MONTGOMERY COUNTY PLANNING DEPARTMENT
THE MARYLAND-NATIONAL CAPITAL PARK AND PLANNING COMMISSION

MEMORANDUM

PROJECT: Woodfield Road (MD124) Widening (Phase I)
From South of Airpark Road to Rosewood Manor Lane
Contract No. MO 6325171

REVIEW TYPE: 1. Preliminary Water Quality Plan
2. Mandatory Referral No. 06815-SHA-1

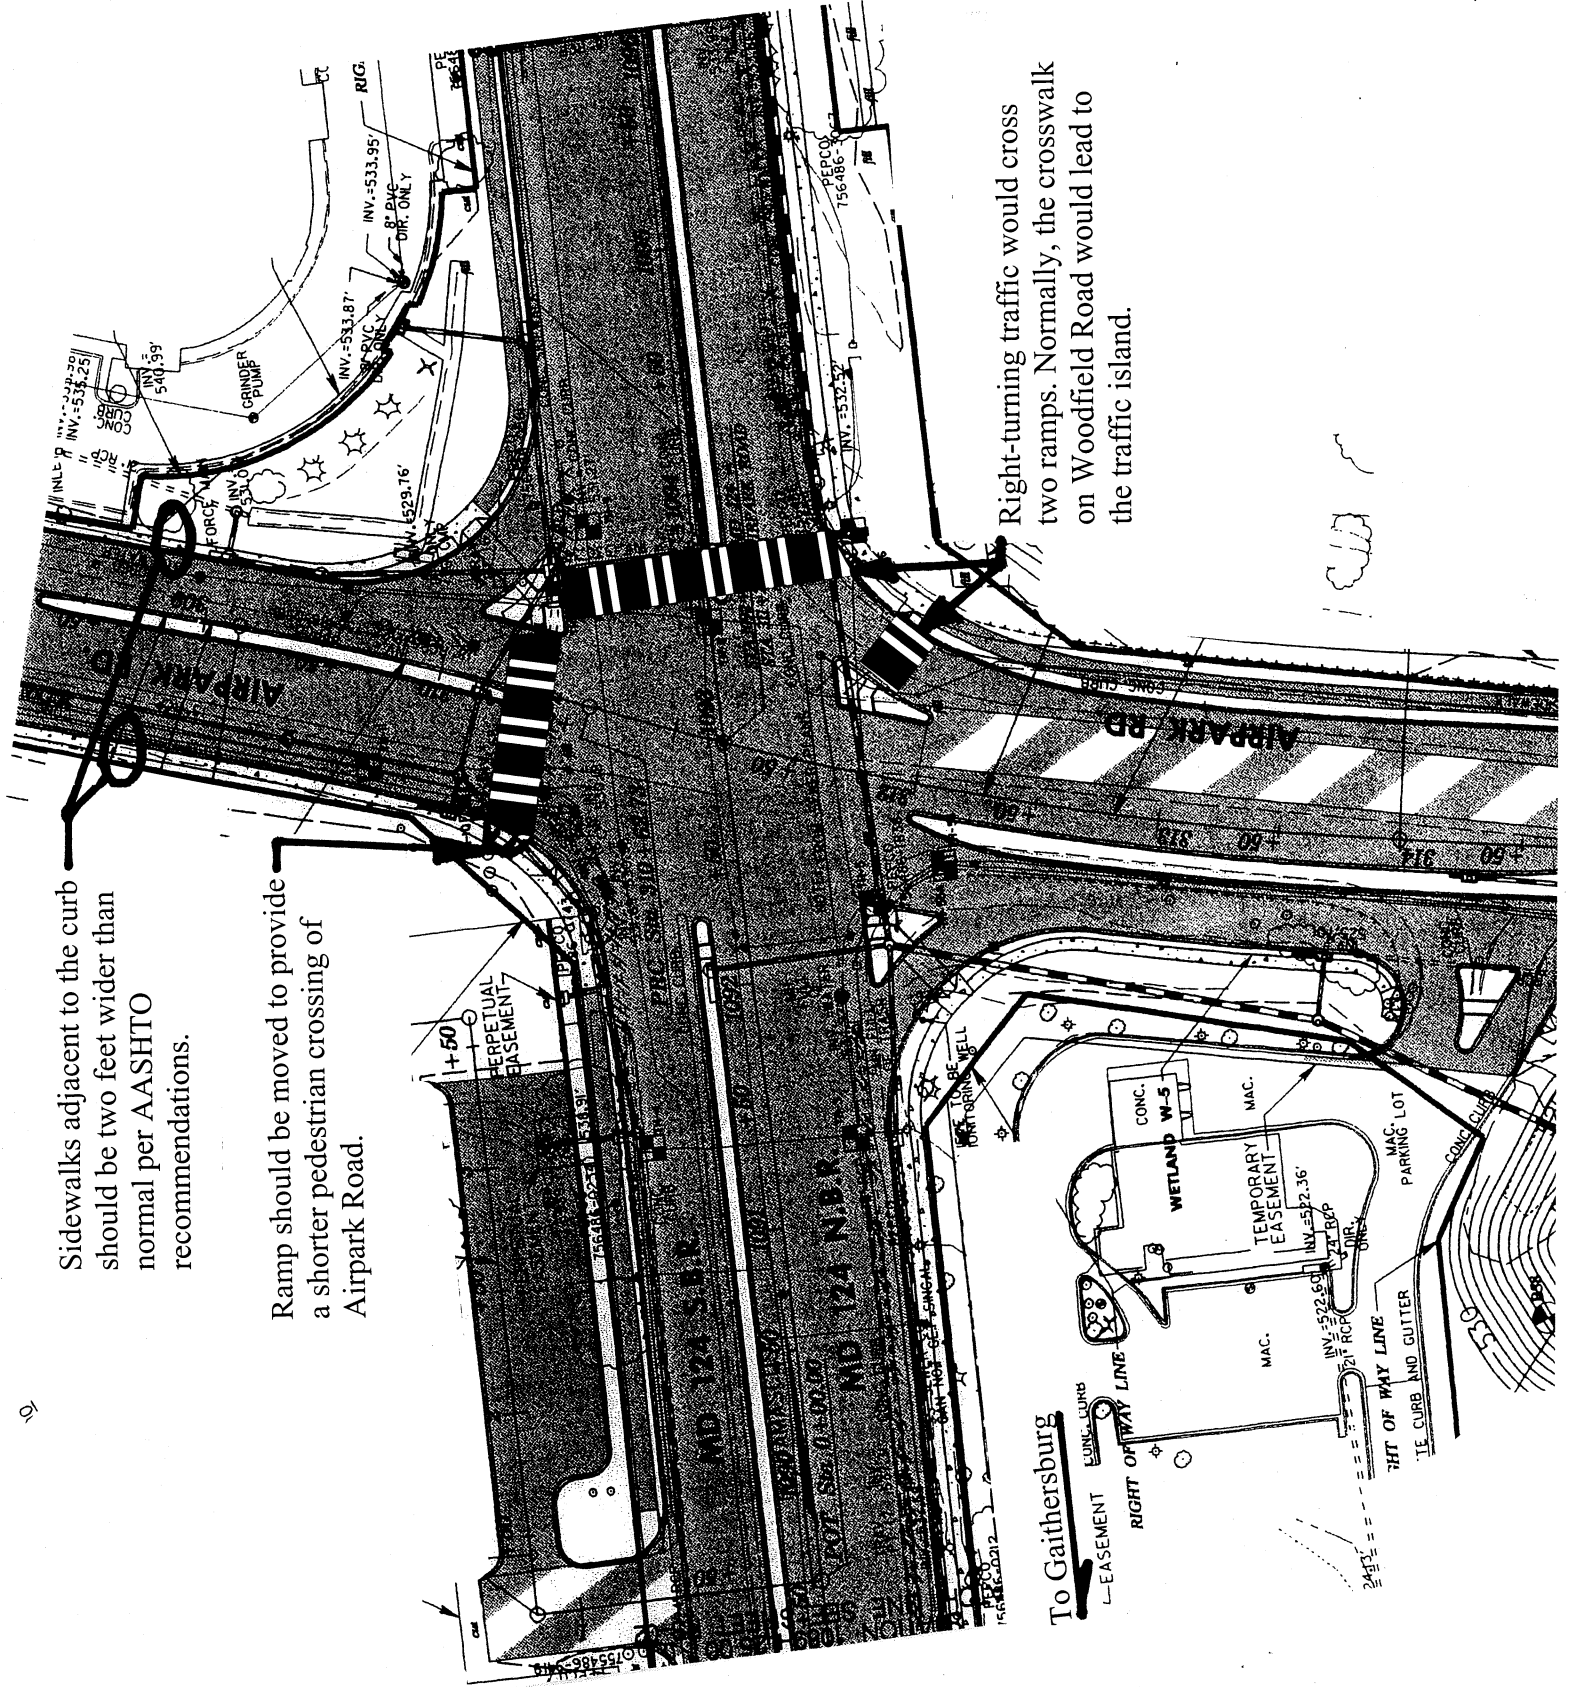
Sidewalks adjacent to the curb should be two feet wider than normal per AASHTO recommendations.

Ramp should be moved to provide a shorter pedestrian crossing of Airpark Road.

Right-turning traffic would cross two ramps. Normally, the crosswalk on Woodfield Road would lead to the traffic island.

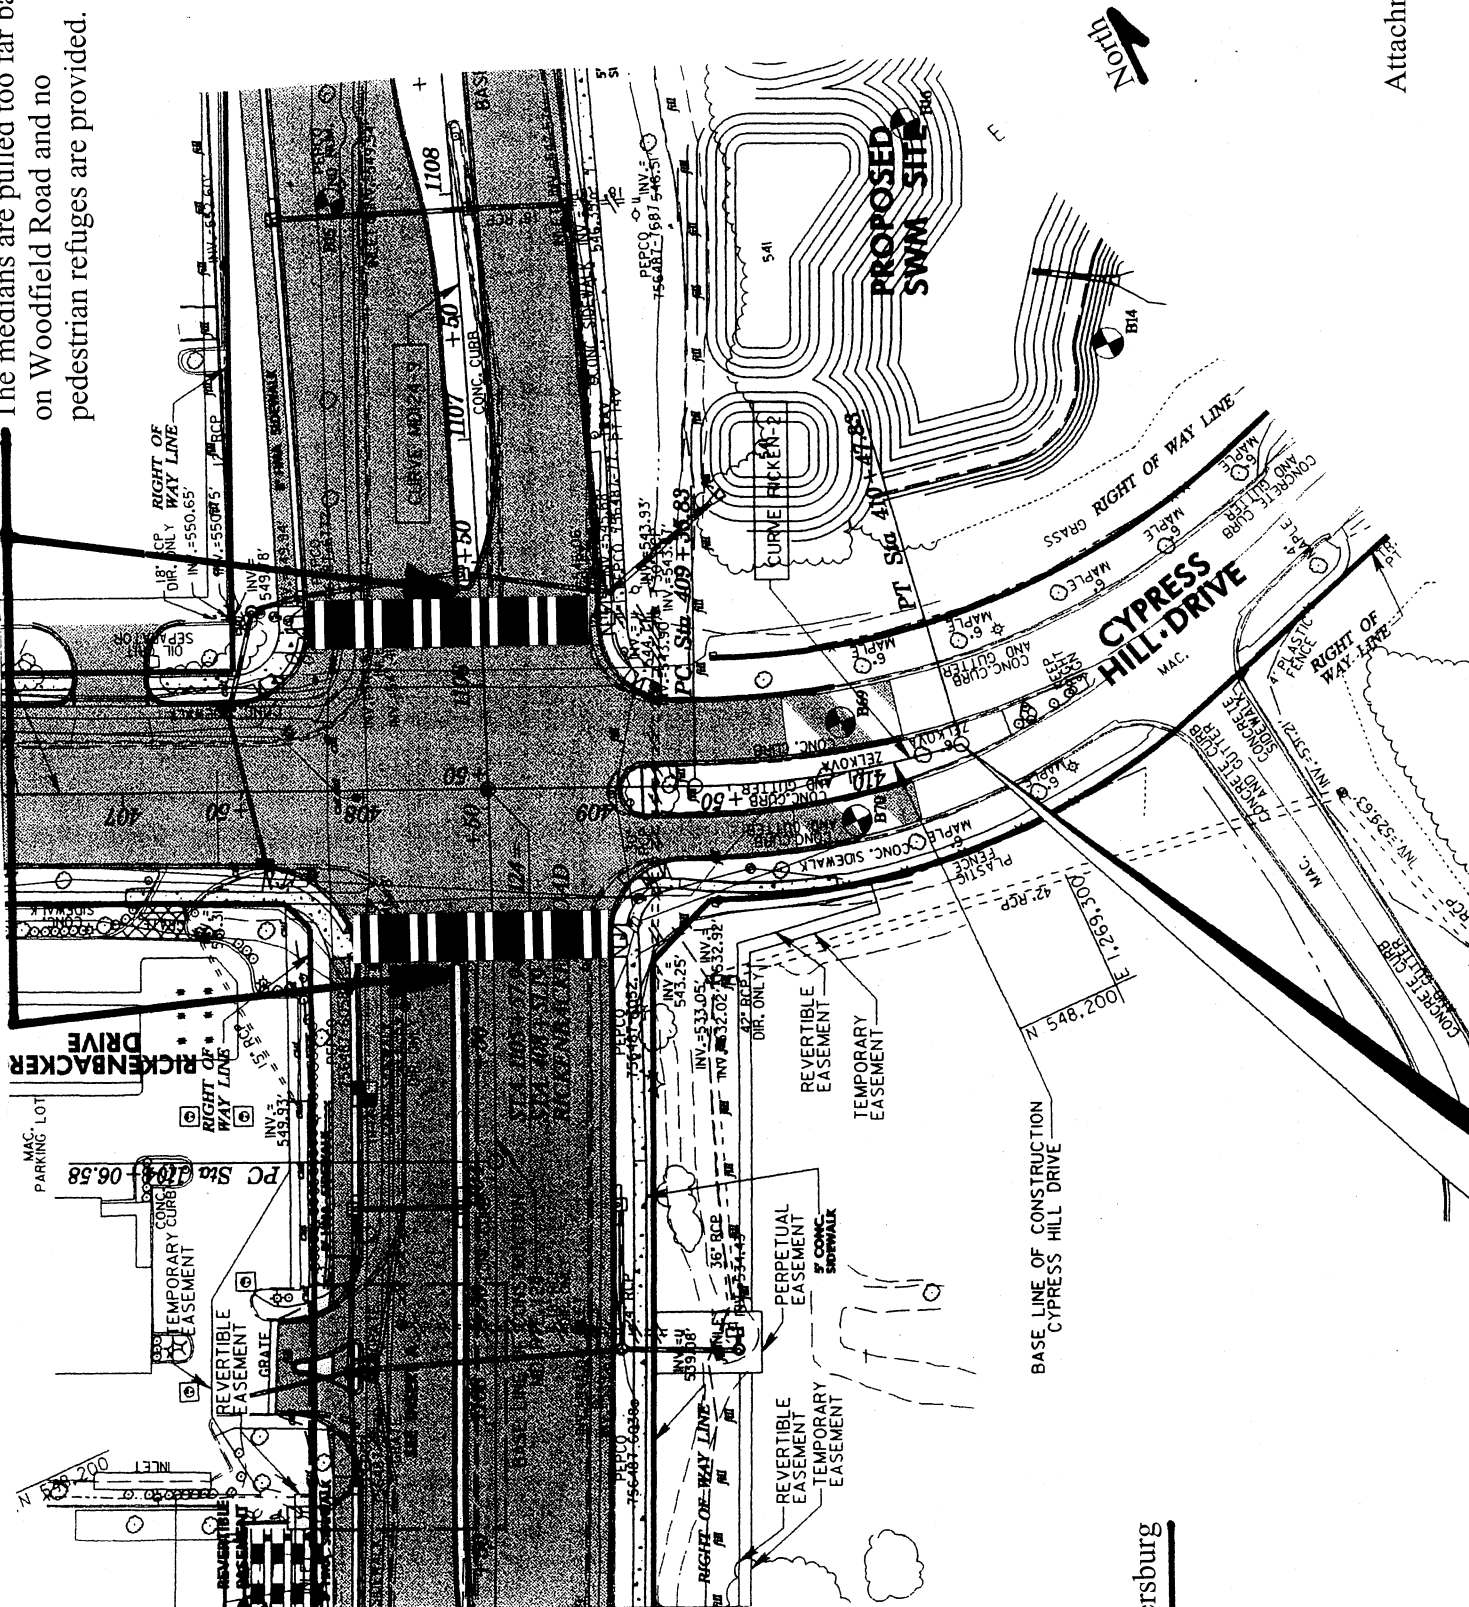
The medians are pulled too far back on Woodfield Road and no pedestrian refuges are provided.

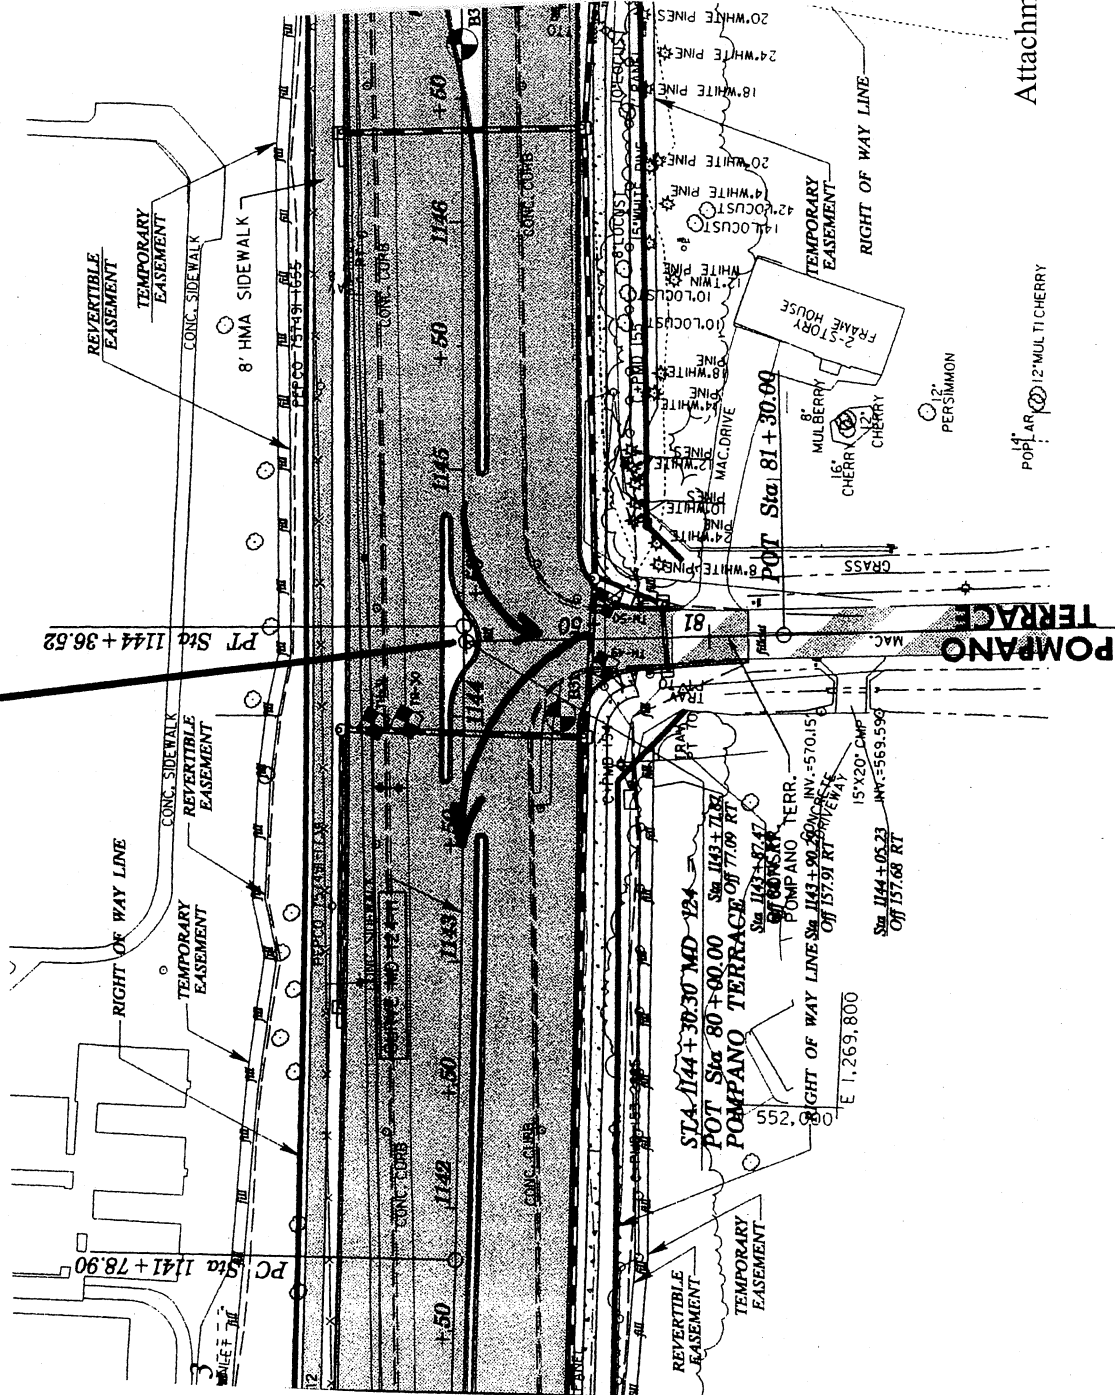
No safe or ADA-accessible
pedestrian crossing of Woodfield
Road is provided at this intersection.

ROSEWOOD MANOR LANE

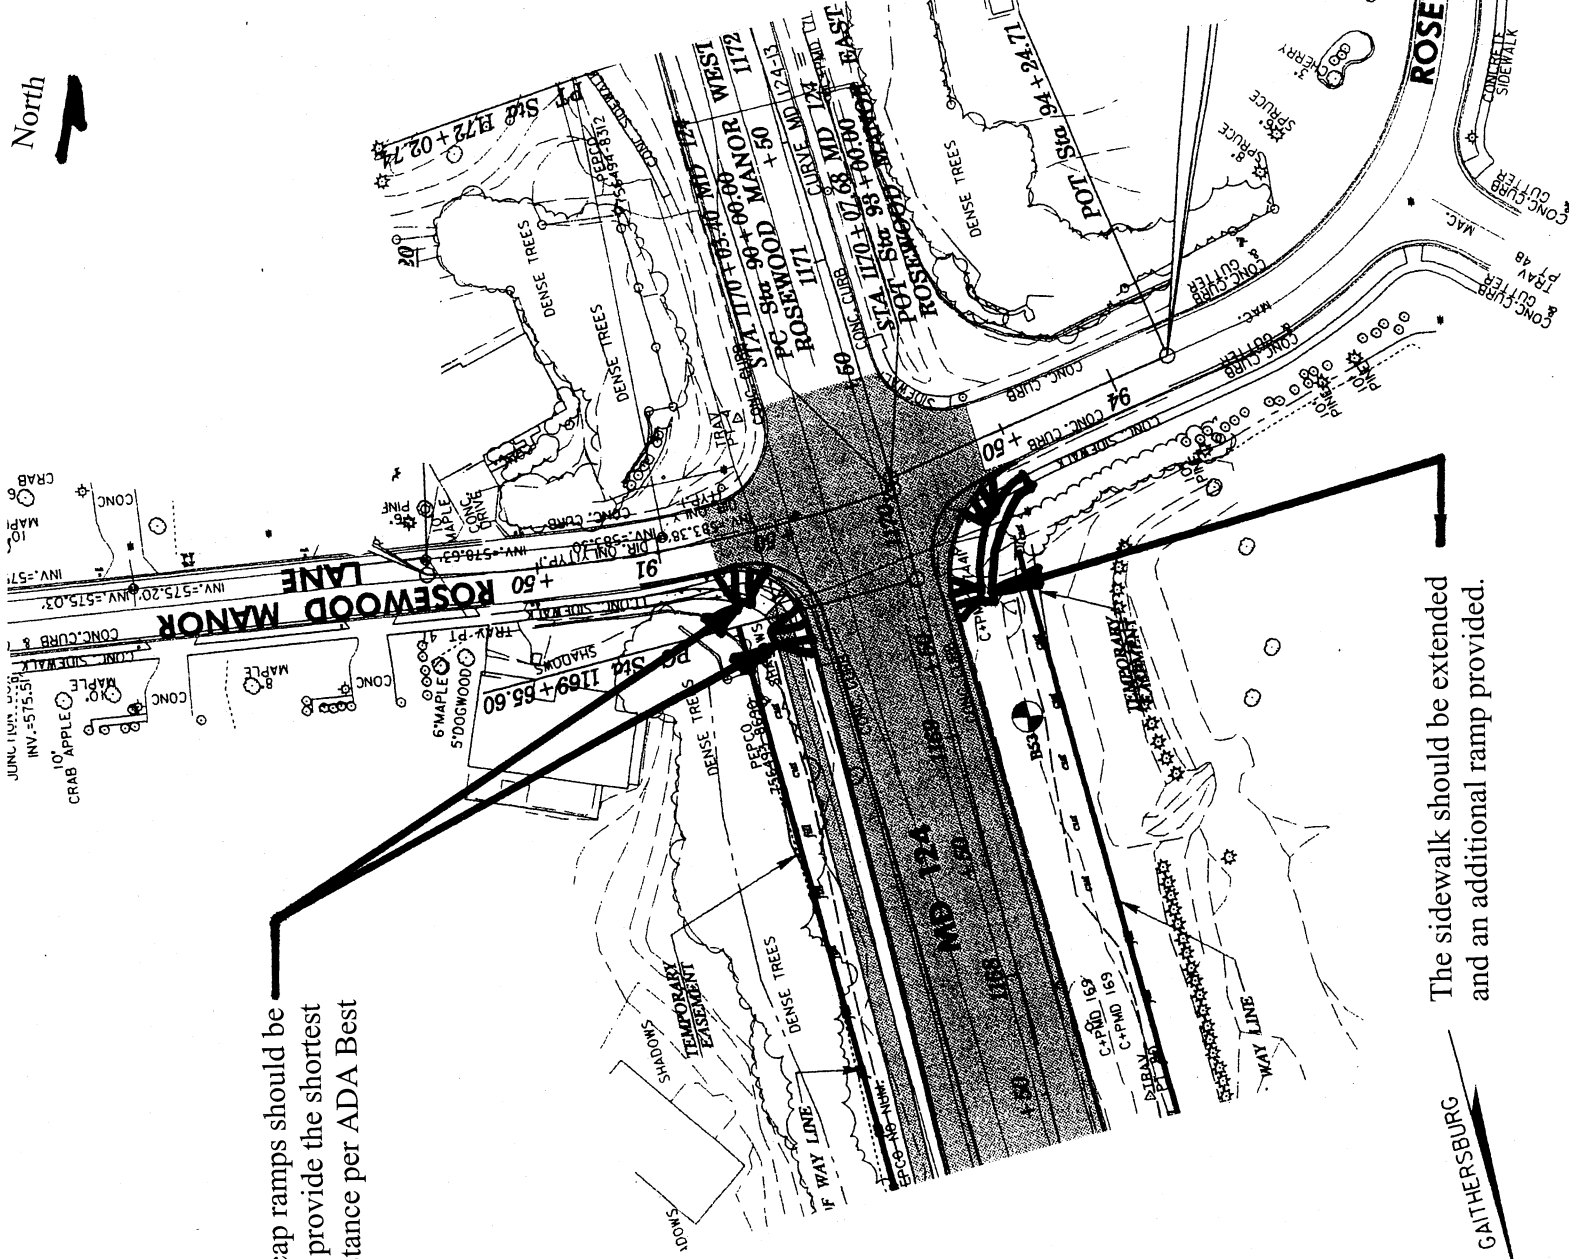
Dual handicap ramps should be provided to provide the shortest crossing distance per ADA Best Practices.

The sidewalk should be extended and an additional ramp provided.
